# Metropolitan Planning Commission

Staff Reports

June 9, 2022

#### Proposed site plan

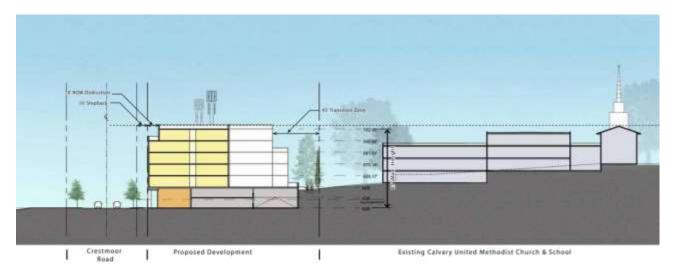
A commercial space will be located on the first floor, along with a lobby and trash and loading areas. Structured parking begins on this level behind the active streetfront uses and also occupies part of the second floor. A note indicates that automobile and bicycle parking will be provided per the UZO requirements of the Zoning Code, but NDOT conditions of approval require the project to be parked per Code. Grading plans show the parking underground at the rear of the site due to slope. Grade changes to the north also prevent the height of the building from exceeding that of the Methodist Church on the adjacent parcel. The building will be set back 20 feet from the rear property line. The ingress/egress is planned for the western corner and will also provide loading/unloading and trash access. Streetscape improvements are in line with the MCSP for Crestmoor Drive, a collector avenue, and include a 2-foot bike buffer, a 7-foot protected bikeway, 8 feet of parallel parking interspersed with 8-foot landscape bulb-outs for street trees,

and a 9-foot sidewalk. The parallel parking will be removed on the corrected plan set per NDOT conditions of approval. Part of these improvements will be included in an 10-foot-wide ROW dedication to be made with a final plat.

- 2. On the corrected plan set, add note: "A Type D bufferyard, if smaller than 30 feet wide, must include an 8-foot-tall masonry wall and 4 canopy, 3 understory, and 15 shrubs per 100 linear feet. Buffer yards will be compliant with Code across the rear of the site."

- 3. On the corrected plan set, replace all architectural standards on Page 11 with the following:
  - a. Building façades fronting a street shall provide a minimum of one principal entrance (doorway) and a minimum of 15% glazing.

# **Proposed Concept Plan**

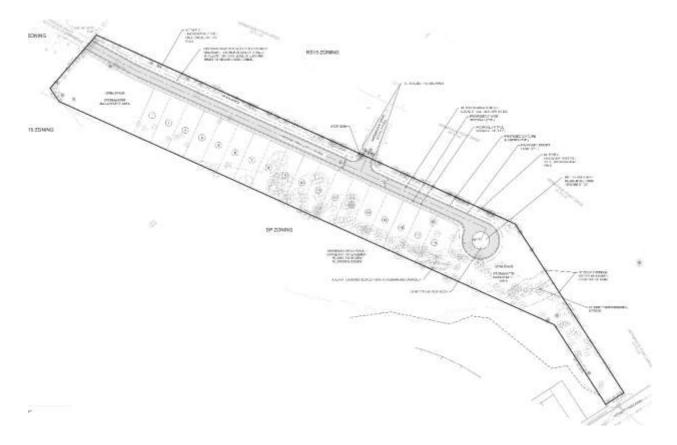
**Subdivision Variances or Exceptions Requested:** Yes. This request requires a variance from Section 3-8, Requirements for Sidewalks and Related Pedestrian and Bicycle Facilities. Section 3-8 requires that sidewalks be constructed on both sides of a new public street. As proposed, the plan includes a sidewalk on only one side of the new street.

• Final construction plans and road grades shall comply with the design regulations established by the Department of Public Works. Slopes along roadways shall not exceed 3:1.

Staff recommends approval with conditions including a variance from Section 3-8 of the Subdivision Regulations.
